DEVELOPMENT NO.:	21031474	
APPLICANT:	14 JOHNSTON PTY LTD	
ADDRESS:	14 JOHNSTON ST STIRLING SA 5152	
NATURE OF DEVELOPMENT:	Construction of a three-level childcare centre (pre-school) with	
	ancillary car parking, outdoor play areas and landscaping	
ZONING INFORMATION:	Zones:	
	Suburban Main Street	
	Overlays:	
	Hazards (Bushfire - Medium Risk)	
	Mount Lofty Ranges Water Supply Catchment (Area 2)	
	Native Vegetation	
	Prescribed Water Resources Area	
	Regulated and Significant Tree	
	Traffic Generating Development	
	Technical Numeric Variations (TNVs):	
	Maximum Building Height (Metres) - 10 Metres	
	Maximum Building Height (Levels) - 2 Levels	
LODGEMENT DATE:	12 Oct 2021	
RELEVANT AUTHORITY:	Assessment Panel at Adelaide Hills Council	
PLANNING & DESIGN CODE VERSION:	Operative Version 2021.14 - (23 September to 13 October 2021)	
CATEGORY OF DEVELOPMENT:	Code Assessed - Performance Assessed	
NOTIFICATION:	Yes

The purpose of this report is to present the amended proposal to the Council Assessment Panel for consideration.

STIRLING CHILDCARE CENTRE

TOWN PLANNING - 30/08/22

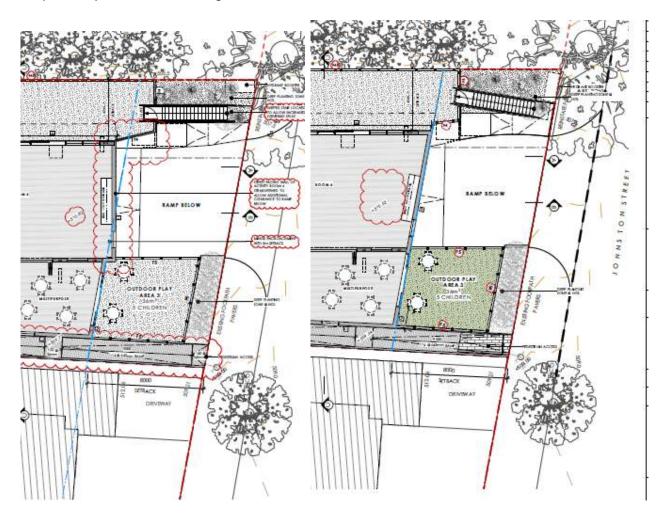
- Straightening of the street facing walls to provide additional ramp clearance. This results in a minor encroachment of the 8-metre setback above the driveway entry ramp.
- Shifting of the stair position and slight straightening of the bottom of the exit ramp to allow for the additional driveway splay as recommended by traffic engineer's advice.
- Minor adjustment to the finished floor levels of building level 1 (200mm) to provide additional safety
 margin/clearance as per waste engineer's advice, noting that there has been no overall change to the building
 height.

These are demonstrated with side by side snip images below for ease of reference with the proposed on the left and the previously considered on the right.

PROPOSED - 3D REPRESENTATIONS

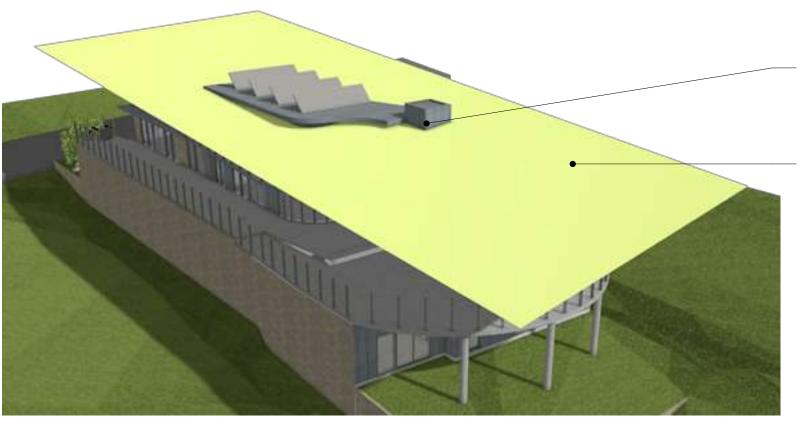
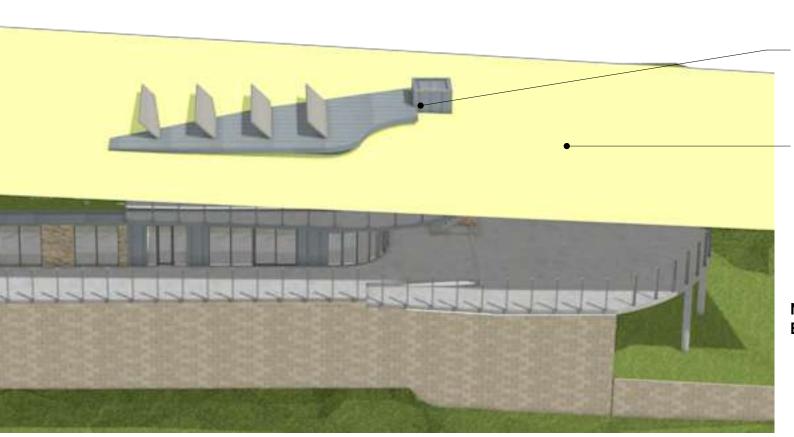
The matter of building height has been clarified further, with each of the amended proposal elevation drawings having a 10metre building height line drawn for reference. The proposal only deviates from the proposed 10 metre DPF in small portions of the northern side elevation. Noting the fall of the subject land and that of neighbouring land and the greatest height deviation is created by the lift overrun, the variation in height is not significant. There is a small section of room 5 and the staff facilities on level 2 which exceed the building height. The following elevation snip is of the portion which exceeds the 10 metre height.

It is argued the lift overrun falls into any other structure in point 4. In any event the DPFs are not considered definitive and a performance assessment would suggest the deviation from Suburban Main Street Zone DPF3.1 is not considered a significant matter which should hinder support for the amended proposal.

AREA OF ENCROACHMENT ABOVE 10m BUILDING HEIGHT BY LIFT OVERRUN, PV PANELS AND CORNER OF UPPER LEVEL ROOF (NOM. 800mm)

AREA OF ENCROACHMENT ABOVE 10m BUILDING HEIGHT BY LIFT OVERRUN, PV PANELS AND CORNER OF UPPER LEVEL ROOF (NOM. 800mm)

Figure 4-6: Truck position in driveway to maintain 900mm footpath clearance. Based on preliminary architectural design.

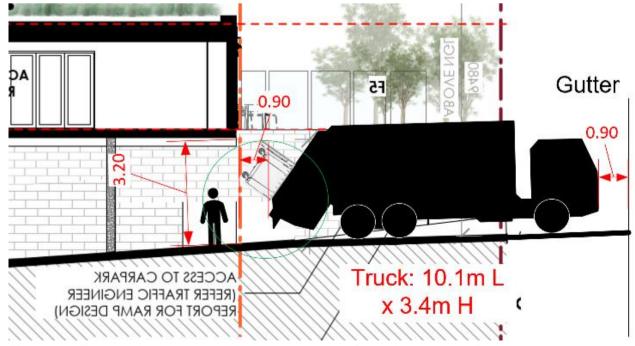
The position of the stopped truck may allow a footpath clearance of 900mm between the front of the truck and the gutter, including leaving 900mm at the rear of the truck to provide clearance for the lifting of an 1,100L skip bin. The position is shown in Figure 4-6, with drawings based on the preliminary architectural drawings and truck operating dimensions provided by Murray Bridge Recycling (10.1m x 3.4m truck and bin with maximum height of 3.12m when being lifted).

• Further the proposal includes footpath and kerb alterations which result in a 900mm footpath remaining trafficable when the waste collection vehicle is parked on the site.

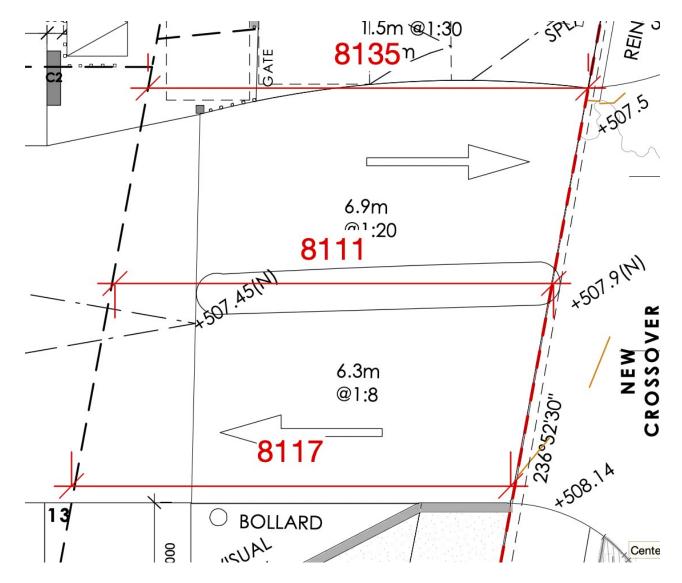
Please see attached Council engineering marked up plan and following some comments:
